SAFETY EVALUATION BY THE OFFICE OF NUCLEAR REACTOR REGULATION

SUPPORTING AMENDMENT NO. 18 TO LICENSE NO. DPR-58

DONALD C. COOK NUCLEAR PLANT UNIT NO. 1

FIGURE 2.1

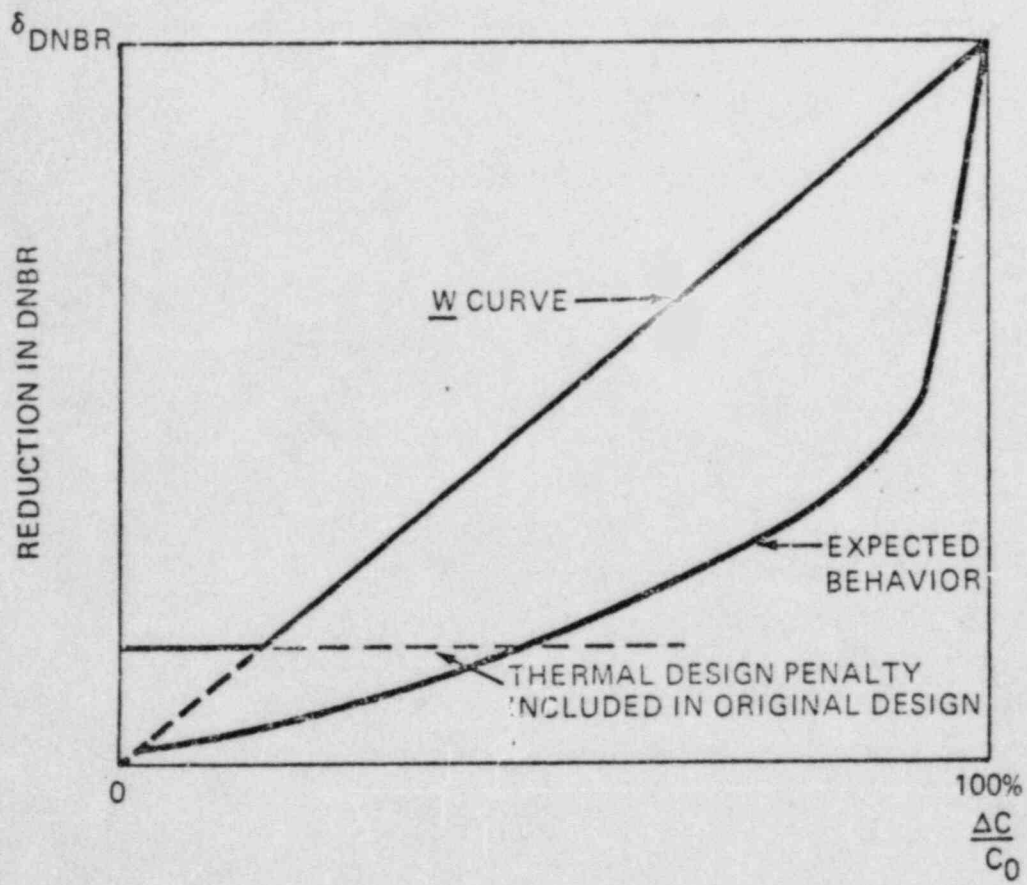
As stated in Section 2.1, data were presented by Westinghouse for the DNBR reduction at full contact and with no bow. No data at partial gap closure were presented. Westinghouse proposed, and the staff accepted, a straight line interpolation between these two points as shown in Figure 2.1.

This approach is conservative if the DNBR reduction does not increase more rapidly than the straight line reduction shown in Figure 2.1. Although the data for DNBR reduction due to rod bowing in the presence of an unheated fuel rod cannot be predicted by existing analytical methods, one would nevertheless expect that the actual behavior would more nearly follow the curved line also shown in Figure 2.1. According to this curved line, the DNBR would be reduced gradually for small amounts of bow. As the fuel rods (or fuel rod and unheated rod) become close enough so that there is an interaction, the DNBR would decrease more rapidly. No physical mechanism has been postulated which would lead to sudden large decreases in the DNBR for small or moderate gap closures. Thus, the straight line approximation is believed to be an overestimate of the expected behavior.

In developing the interim rod bow penalties described in this report, it became apparent that the penalty should be a function of burnup since the magnitude of rod bow is a function of burnup. However, to maintain existing thermal margins early in core life when only a small amount of fuel rod bow is anticipated, the initial pitch reduction factor was included until such time as the rod bow DNBR reduction became greater. This is represented as the straight horizontal line on Figure 2.1.
